Change Order

22-000054 95 SW 5th AVENUE COMMERCIAL
BUILDING CONSTRUCTION (CRA)
DELRAY BEACH, FL 33444

Change Order: **92**

OPENINGS AT FRONT OF BUILDING CHANGED TO 16"X12"

S20

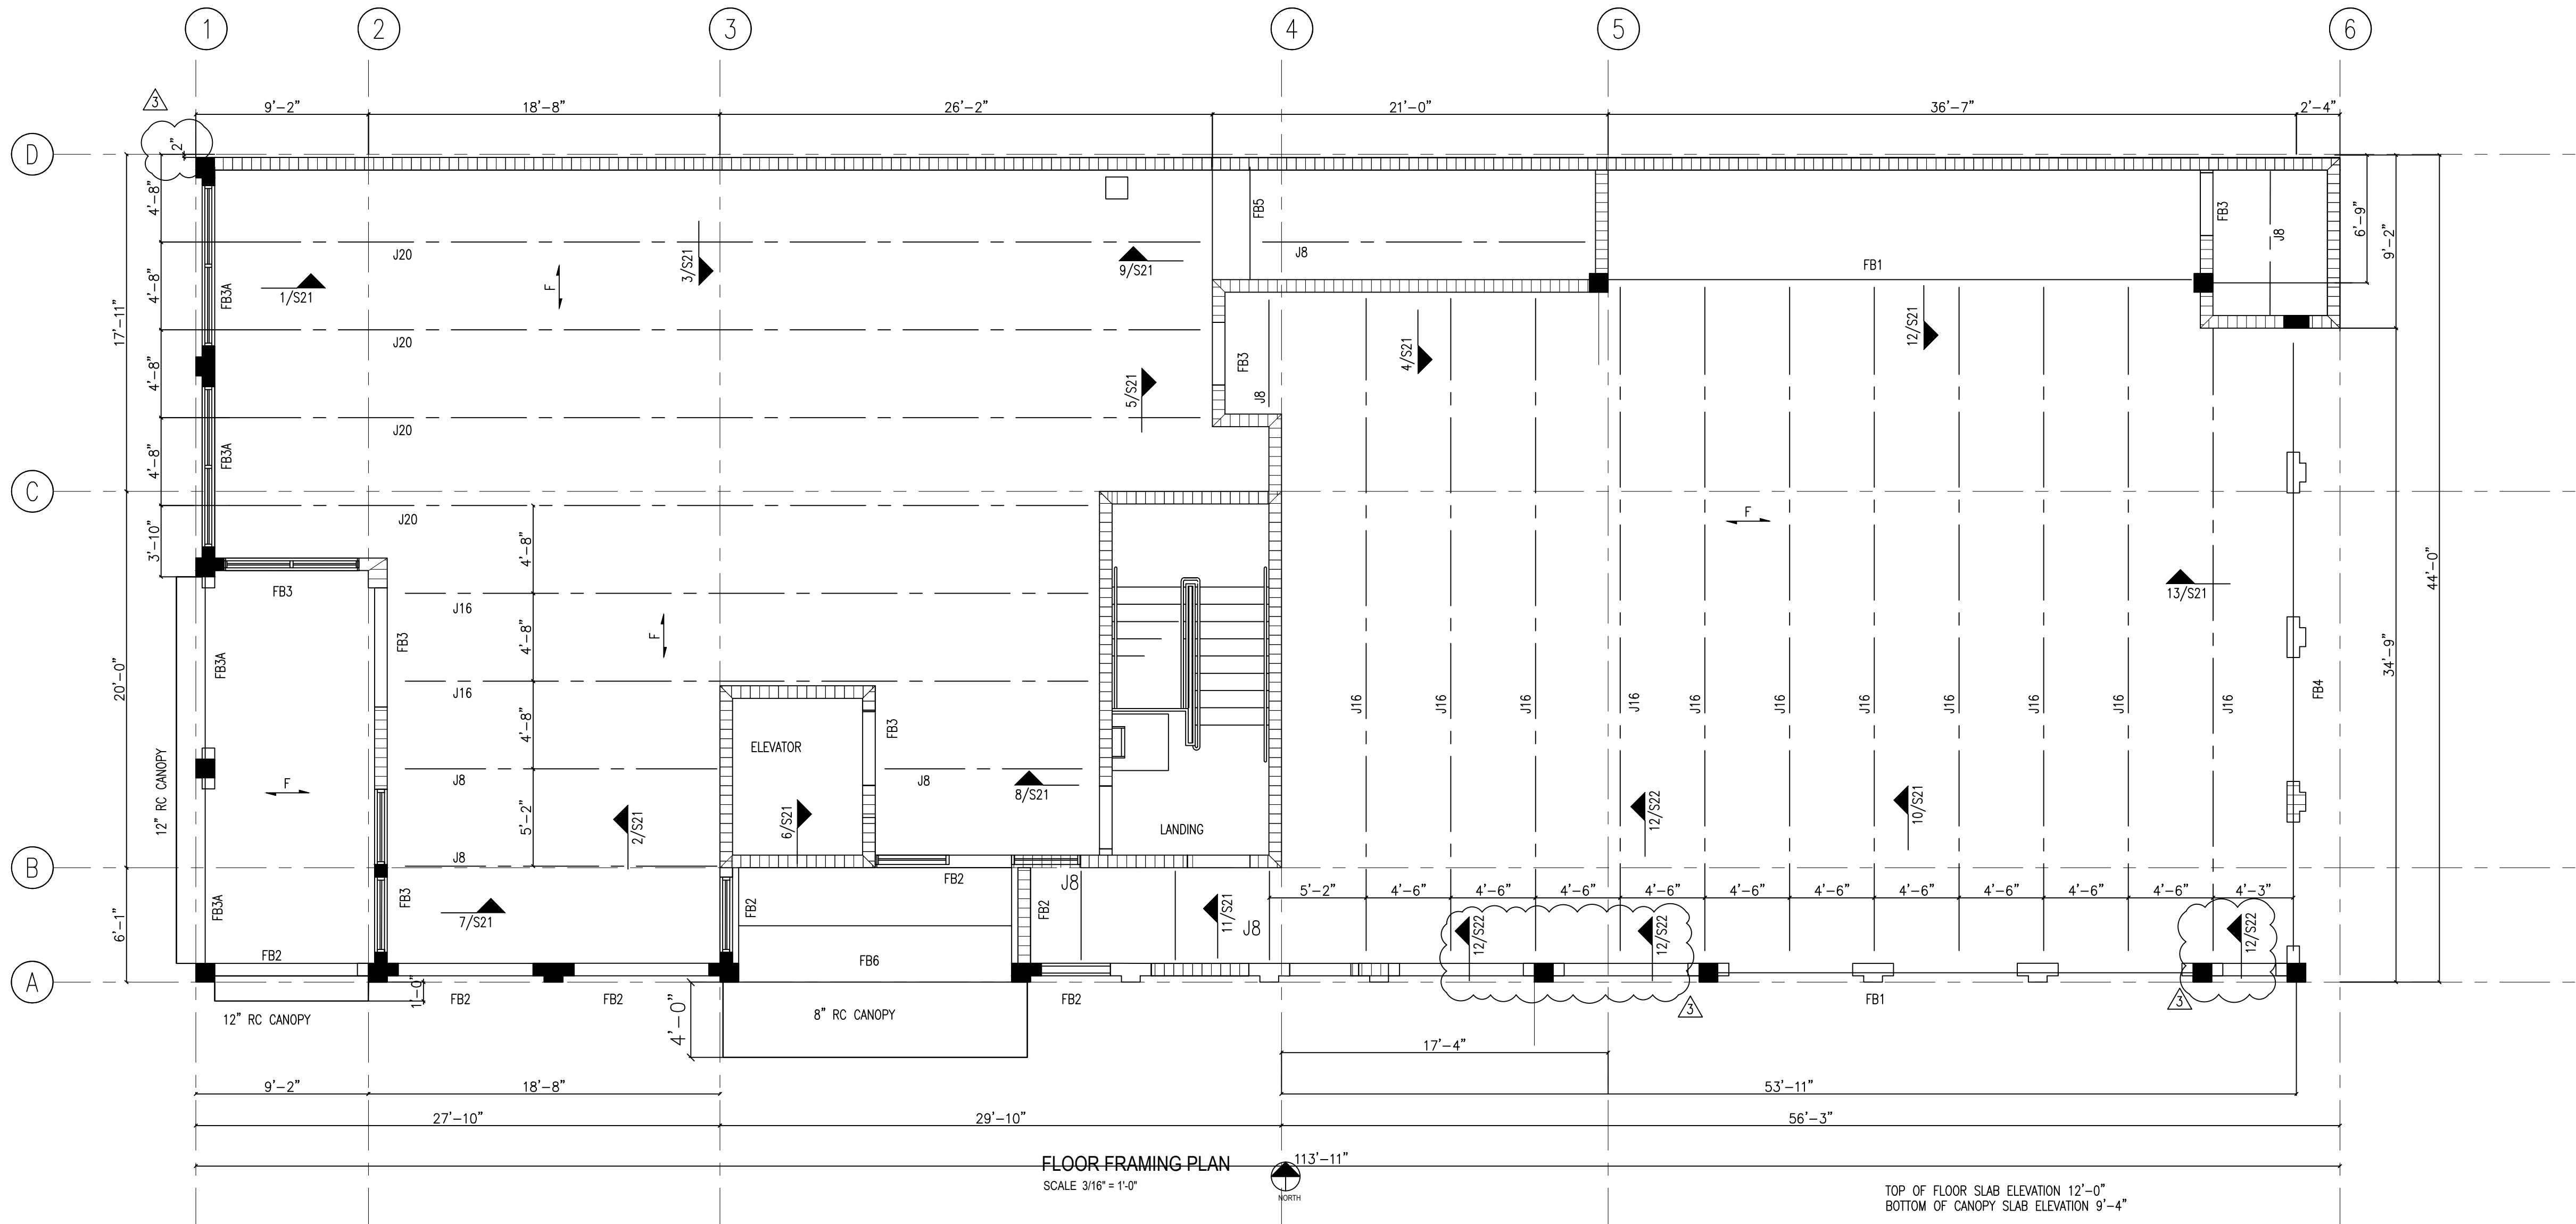
MODIFY (3) OPENINGS BETWEEN 12X12 COLUMNS AT FRONT OF BUILDING WITH NEW DESIGN OF 16"X12" BEAMS AND
THE ADDITION OF 25LF OF SILLS NEEDED FOR OPENING.

THESE CHANGES CAN BE FOUND ON DRAWING S20 REV 3 DATED 1/29/2024, ATTACHED
